Our ref: AC/2024/132088/01-L01
Your ref: WW010003
Date: 12 April 2024

CAMBRIDGE WASTE WATER TREATMENT PLANT RELOCATION REVISED FLOOD RISK ASSESSMENT

Figure 1

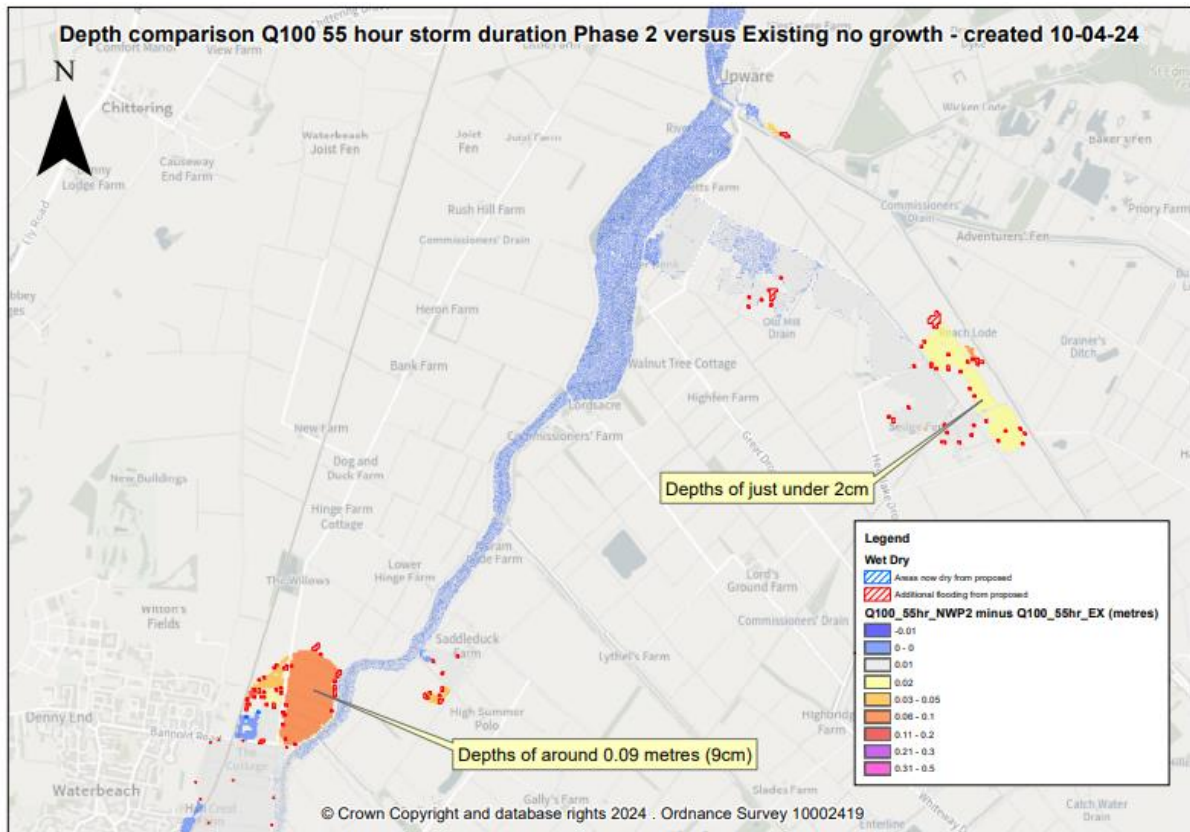
Figure 1 below shows the 1 in 100 year flood event or 1% AEP for a 50 hour storm event with the existing baseline flood depths compared to the flood depths for Phase 2 future baseline proposed growth for 2041. There is an increase to an area with properties of up to 9cm flood depth. This is above an acceptable modelling tolerance and assumption range.
